**CHANDIGARH
HOUSING BOARD**
A CHANDIGARH ADMINISTRATION UNDERTAKING

Subject : Additional construction / violations in Duplex Flats in Sector 41-A, Chandigarh.

H. No. 666/1, SEC. 41-A

SECOND FLOOR PLAN

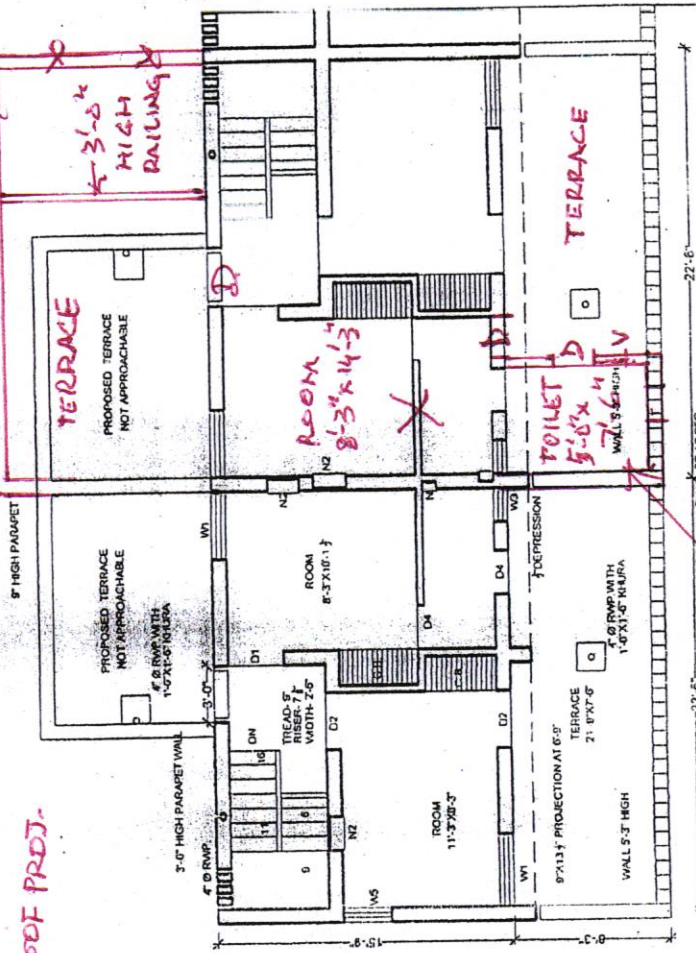
Additional room at first floor is not

As such, you are advised to remove / set right the violations as per standard drawing of CHB to ensure the structural stability / safety **within 30 days** positively under intimation to this office along with Structure Stability Certificate issued by the empanelled Structural Engineer by Chandigarh Administration, failing which the action will be taken by CHB as per rules / policy and as per the directions of Hon'ble High Court.
